US LHC ACCELERATOR PROJECT

Subject: LQX Cryostat Engineering Design Review

LQX Cryostat

12 March 2001

6. **Shipping loads**

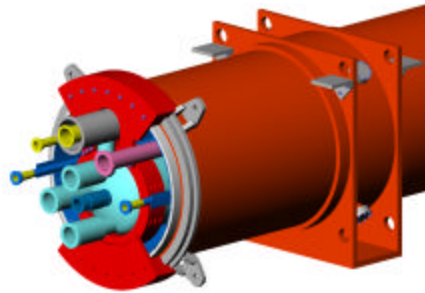
Fermilab has demonstrated that the cold mass support will withstand 2 g of horizontal load before failure. During shipment the ends of the cold mass will also be restrained through a fixture to the vacuum vessel. It is expected that loads experienced during shipping and handling will range higher than 2 g. The heat exchanger test unit experienced one event of 4 g and one of the reviewers believed ocean shipping loads may be as high as 5 g.

Action: Fermilab needs to include shipping restraints that are capable of isolating the cryoassembly from anticipated shipping loads. The resulting loads on the cold mass support need to be kept below 2 g.

13. Stability of thermal shields

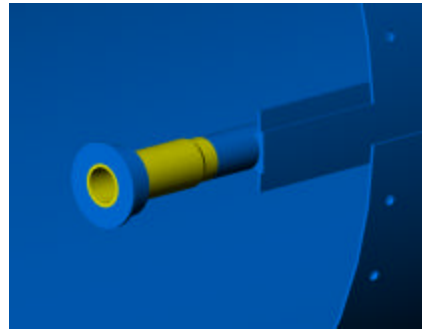
A couple of aspects of the stability of the thermal shields were discussed. It was felt necessary to check the buckling resistance of the extrusion piping under pressure at both maximum operating (22 bar) and test (27.5 bar) pressures. The extrusion has a thermal fin and would be quite stiff in the lateral direction of the fin, but much less stiff in the transverse direction to the fin.

It was also suggested to check for stability against collapse of the thermal shield due to eddy currents in the aluminum shield, especially during a quench.

Action: Fermilab is requested to analyze the resistance of the thermal shield to buckling due to pressure in the extrusion piping and collapse due to eddy currents during quench.

14. Cold mass support

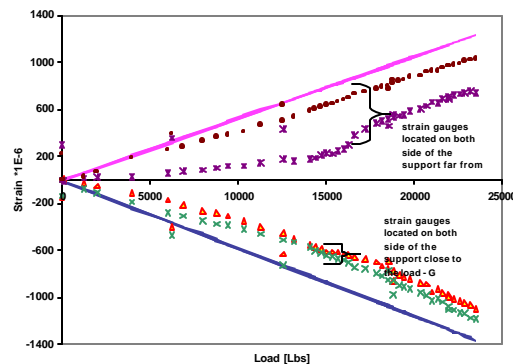
Two cold mass support rings were analyzed and tested to failure during development. The second support ring tested, which represented the final design most closely, failed under a horizontal load of 23,500 lb (105 kN, or 2.2 times the weight of the heaviest cold mass). The reviewers were concerned that the damage might have actually begun at a lower load with small cracks or strain that propagated with increasing load. They suggested that the test data should be reviewed to investigate this possibility.

Action: Fermilab is requested to review the test data to determine the onset of failure.
